New Dubbo Bridge

Addendum review of environmental factors

Transport for NSW

February | 2022

Figure 3-1 Key features of the proposed modification

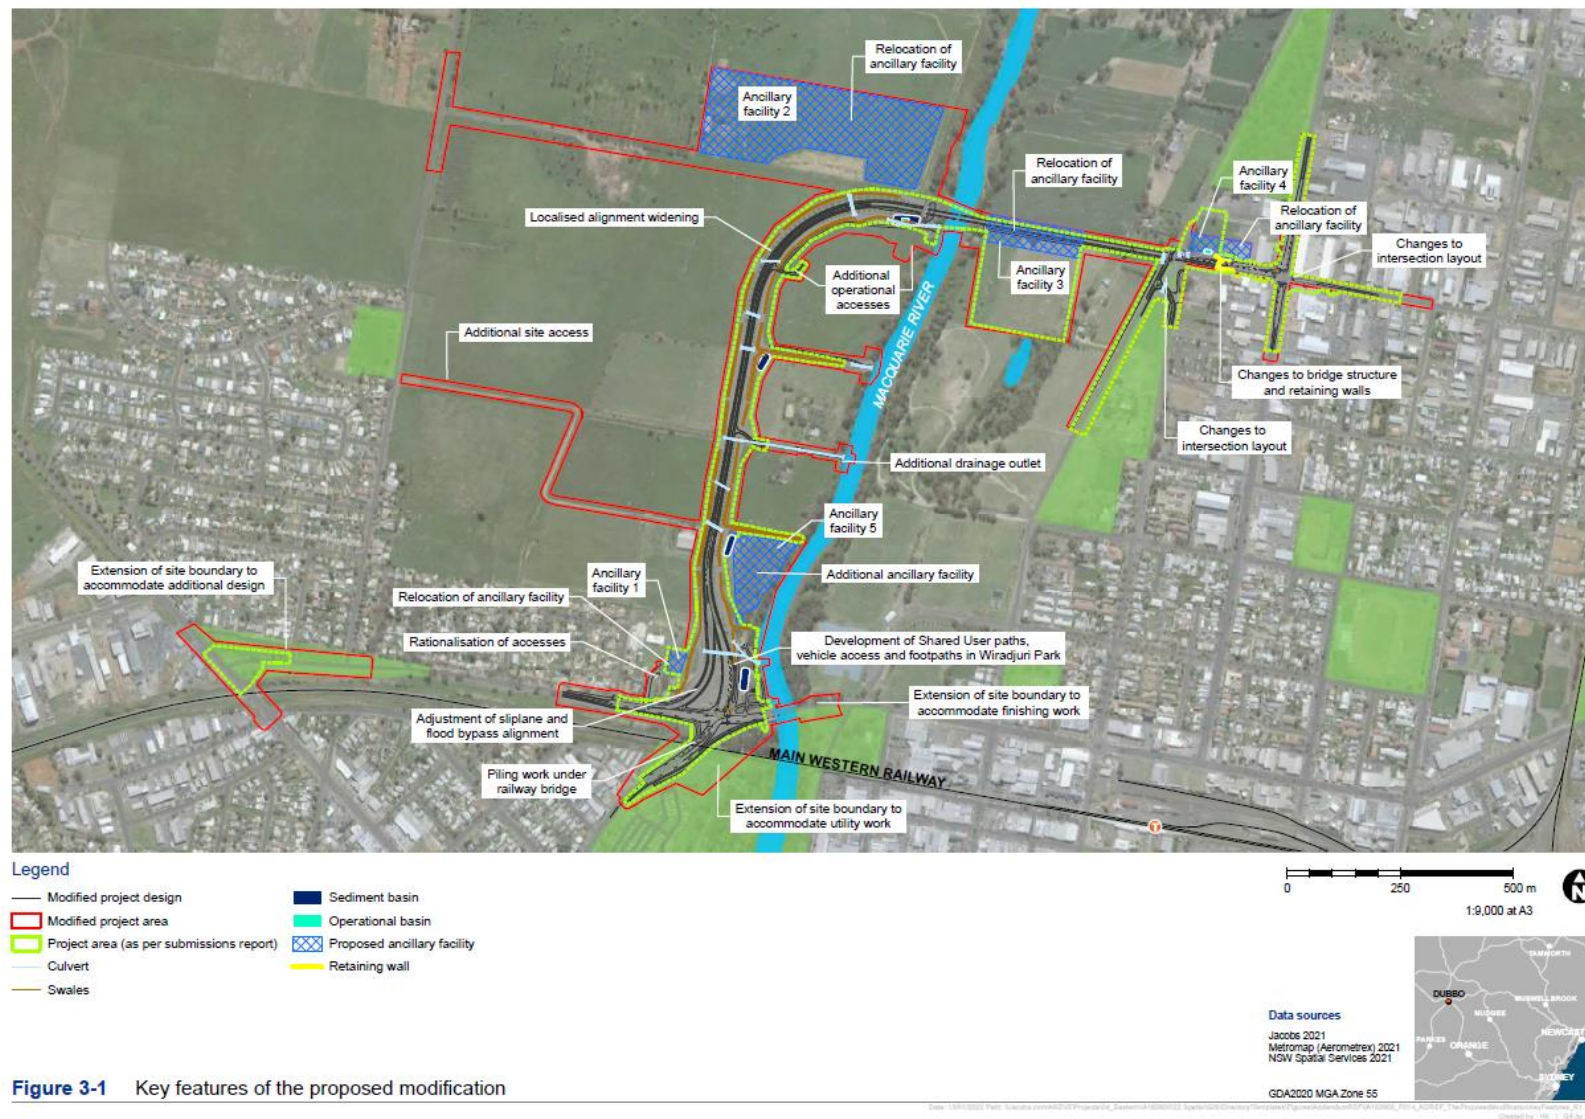
Transport for NSW proposes to modify the New Dubbo Bridge project including refinements to the New Dubbo Bridge structure, layout of the Newell Highway and project intersections, as well as changes to retaining wall and drainage structures, shared path and public access arrangements and landscaping and finishing work (proposed modification) The proposed key features of the modification are shown in Figure 3-1.

The following changes are proposed to the active transport elements of the project, as shown on Figure 3-1:

Figure 3-2 Typical cross section of the proposed modification at New Dubbo Bridge

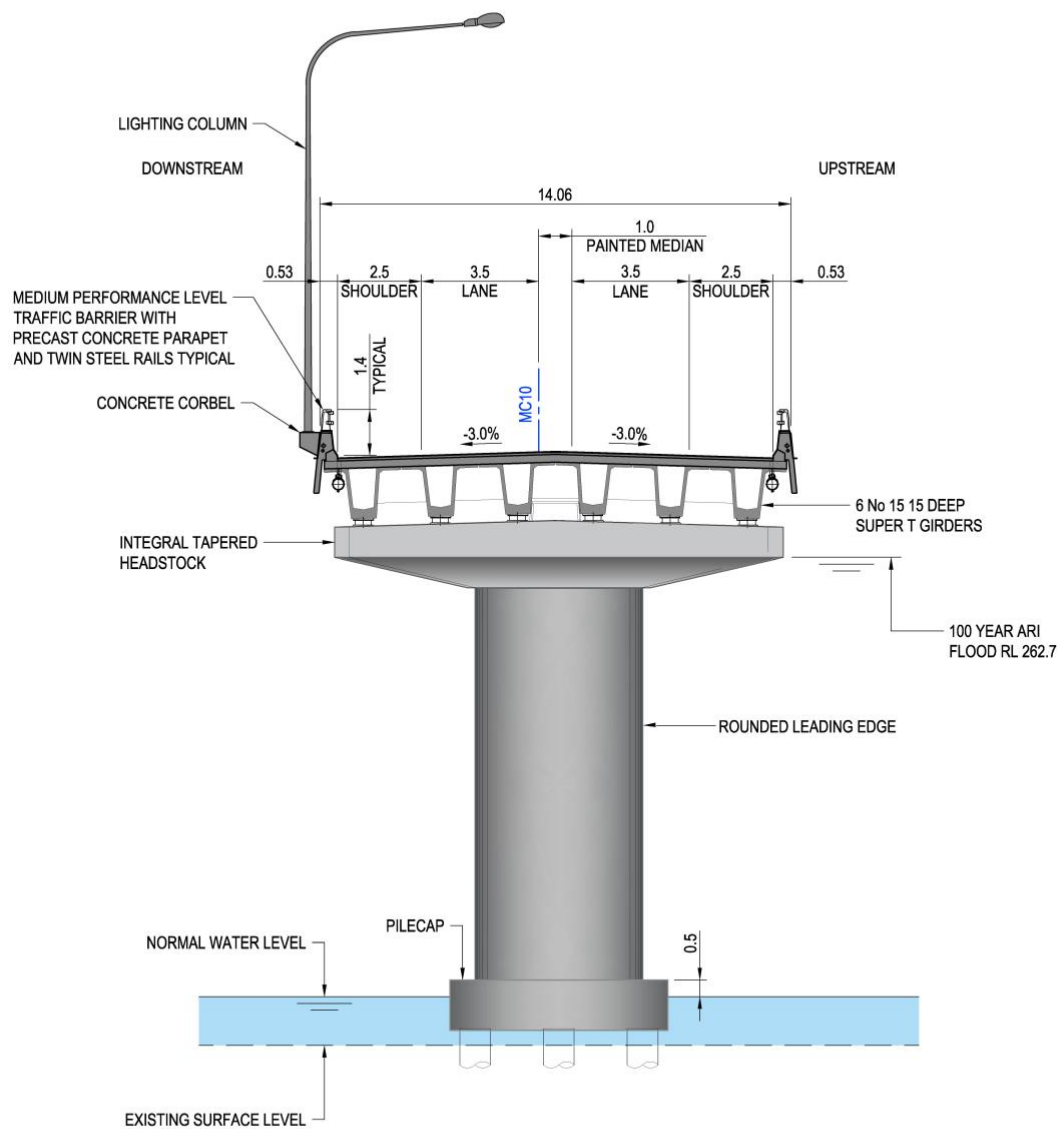
The pier column profile has been modified from tapered to straight to simplify construction, improve aesthetics in line with urban design requirements and enhance material efficiency. The substructure of the modified New Dubbo Bridge is shown in Figure 3-2.

- Piers 1 to 6 comprise six 900 millimetre diameter piles per pier
- Piers 7-17 comprise a single row of three 1200 millimetre diameter piles per pier
- Piers 18 and 19 comprise a single row of three 1050 millimetre diameter piles per pier
- Abutment A comprises a single row of three 900 millimetre diameter piles
- Abutment B comprises eleven 900 millimetre diameter piles.

Figure 3-3 Proposed modified pier arrangements across the New Dubbo bridge

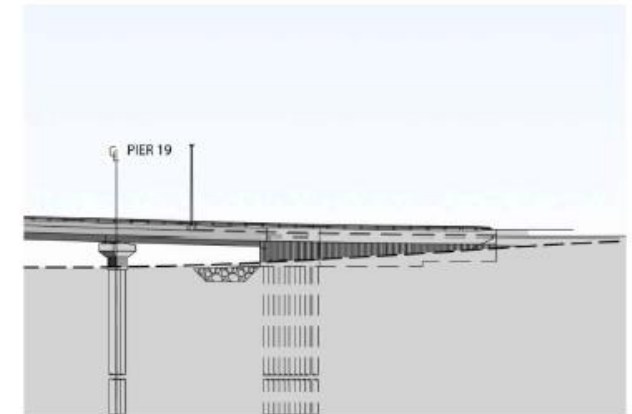
As a result, the modified New Dubbo Bridge would consist of an additional four spans of Super-T girders (20 spans in total) and an additional four piers (19 in total), as shown on Figure 3-3. The reconfiguration of the piers would result in one additional pier located within the channel of the Macquarie River, such that there would now be two instream piers.

Figure 3-4 Modified vertical alignment of New Dubbo Bridge

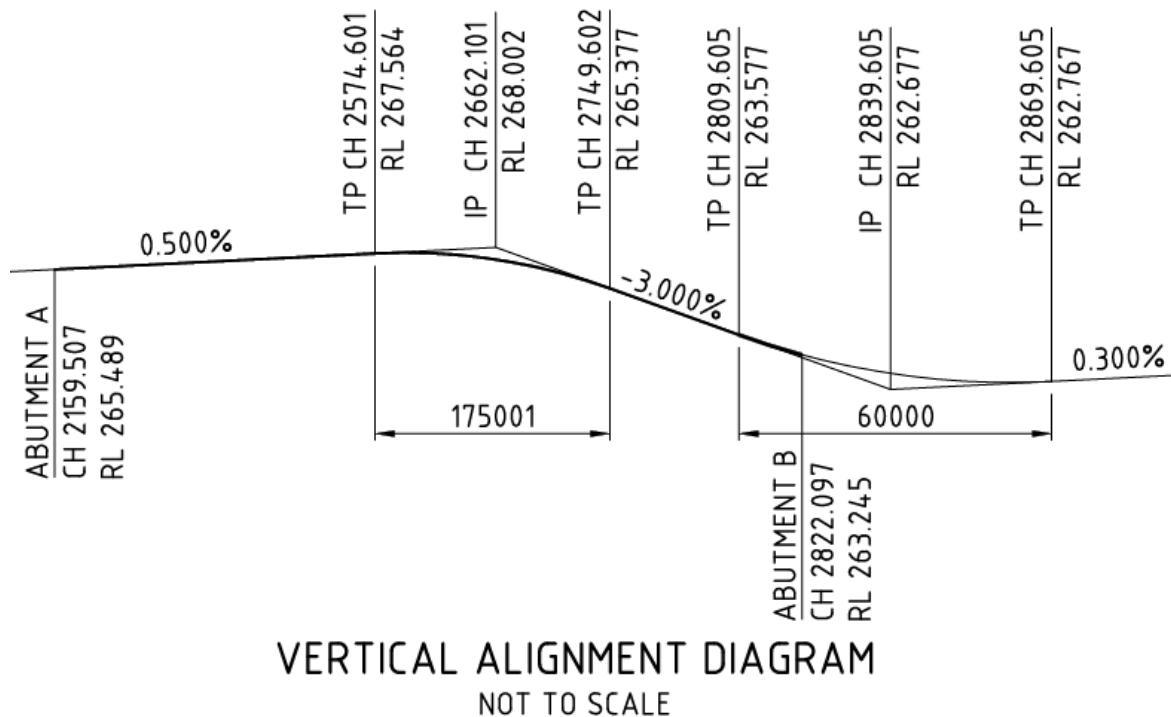
However, in the detailed design the vertical alignment of the Newell Highway parallel to the Macquarie River has been revised to reduce the embankment height to an average embankment height of about 1.5 metres above stripped surface.

The vertical alignment of the New Dubbo Bridge has also been slightly modified such that from the western embankment the bridge would rise on a 0.5 per cent grade, with a crest just west of Brisbane Street, where the alignment then dips down to River Street on a three per cent grade as shown in Figure 3-4. The modified vertical bridge alignment provides flood immunity up to the one per cent average exceedance probability (AEP) flood event (sometimes referred to as the 1 in 100 year flood event), and an increased minimum vertical clearance over Brisbane Street of 6.1 metres.

Figure 3-5 Modified Newell Highway/Thompson Street intersection

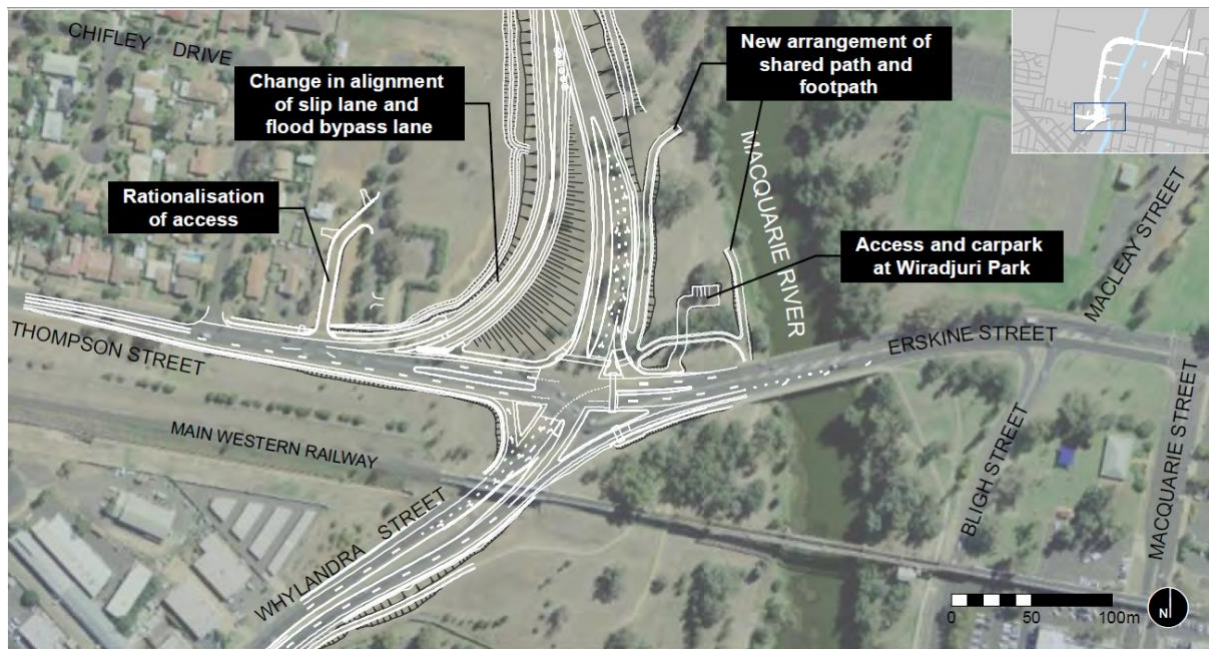
The modified design for the Newell Highway/Thompson Street intersection is shown on Figure 3-5. In addition to the horizontal alignment changes to the northbound slip lane and flood bypass lane, the speed limit on the northbound flood route from Thompson Street has also increased from 40 to 60 kilometres/hour. The speed limit on the southbound route would remain the same. The Newell Highway / Thompson Street intersection has been modified to provide access into Wiradjuri Park.

Figure 3-6 Modified layout schematic for River Street/Bourke Street

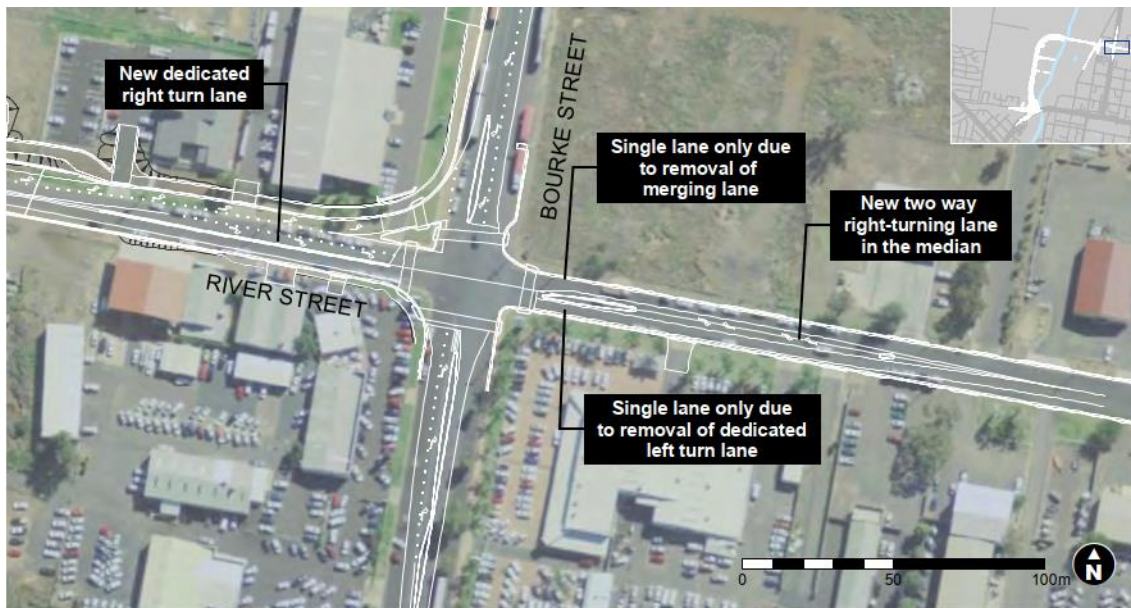
The layout of the Bourke Street/River Street intersection has been modified, as shown in Figure 3-6. Proposed changes to the intersection include:

- Provision of a new dedicated right turn lane from River Street to southbound on Bourke Street
- Removal of the merging lane eastbound along River Street to the east of the intersection
- Addition of a two-way right-turning lane (a lane used for turning right by both directions of traffic) in the median of River Street to the east of the intersection, to provide access to the properties along River Street
- Removal of the dedicated left turn lane from River Street to the southbound direction in Bourke Street
- Removal of informal on-street parking area on River Street located between Brisbane Street and Bourke Street.

Figure 3-7 Modified Brisbane Street/Darling Street intersection

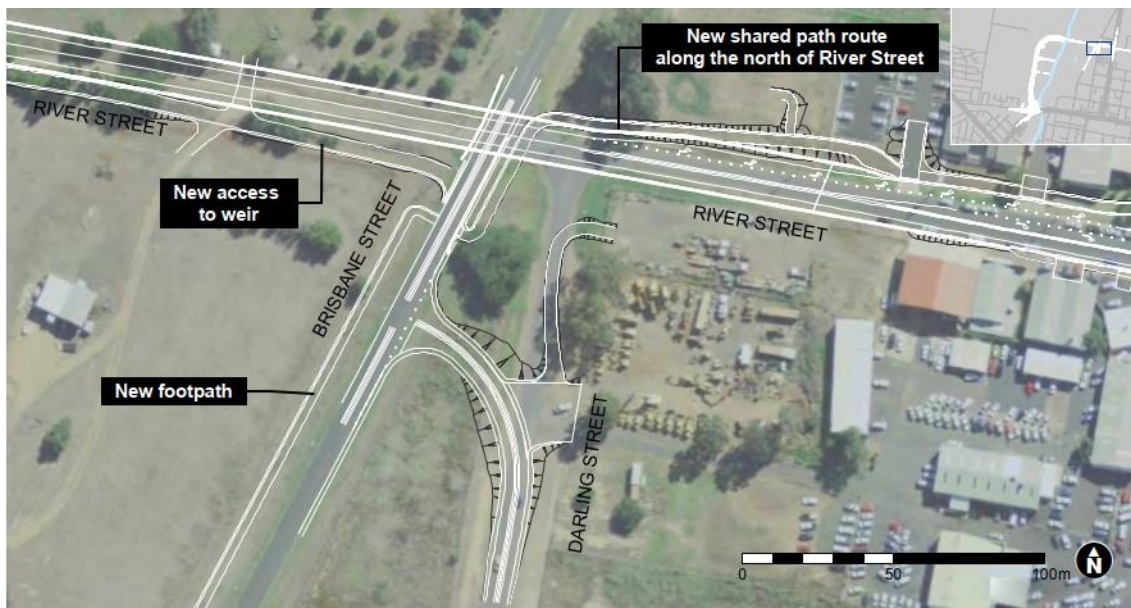
The alignment of Darling Street has been reconfigured slightly through detailed design in order to tie into the existing Brisbane Street. Work at this tie in would be carried out as an early work package and detailed design and construction planning is ongoing, separate to the main project. The updated layout and additional area required is shown in Figure 3-7.

Figure 3-8 Operational spill basin design

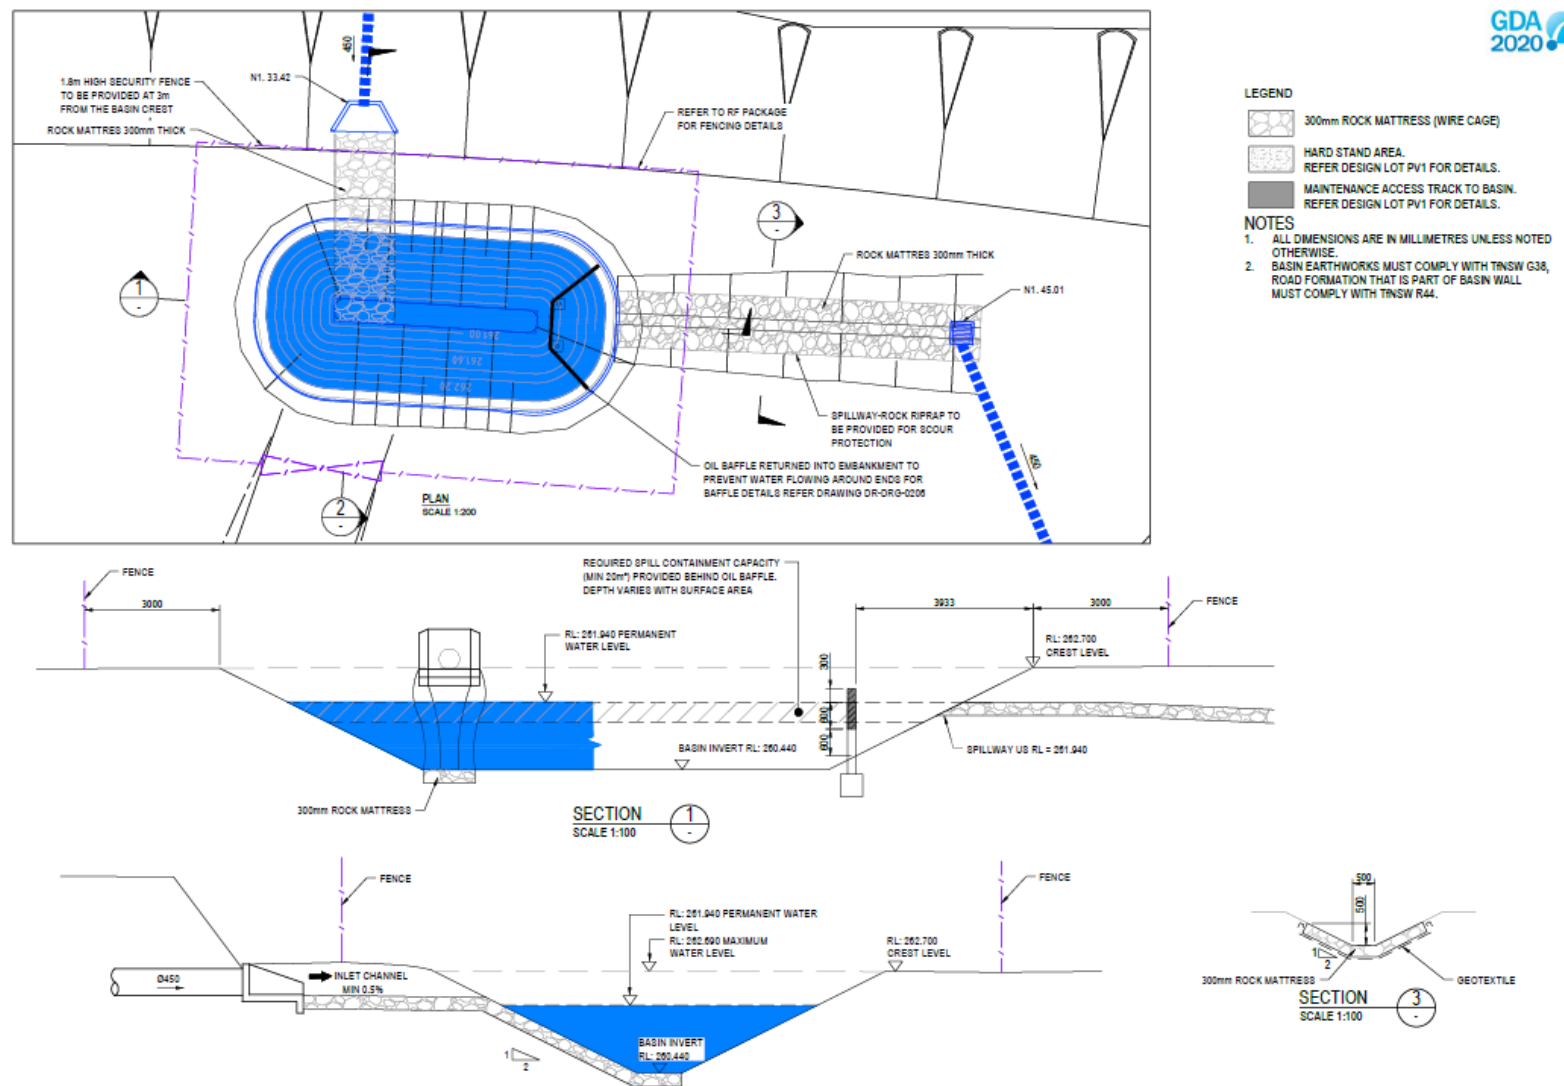
In addition to the operational basin described in Section 3.2 of the project REF, an operational spill basin is proposed at the western end of the New Dubbo Bridge due to the low risk of a large spill occurring on the main bridge deck. The spill basin would be able to capture and accidental spill of up to 30 cubic metres of liquid.

The design of the operational spill basins is provided in Figure 3-8.
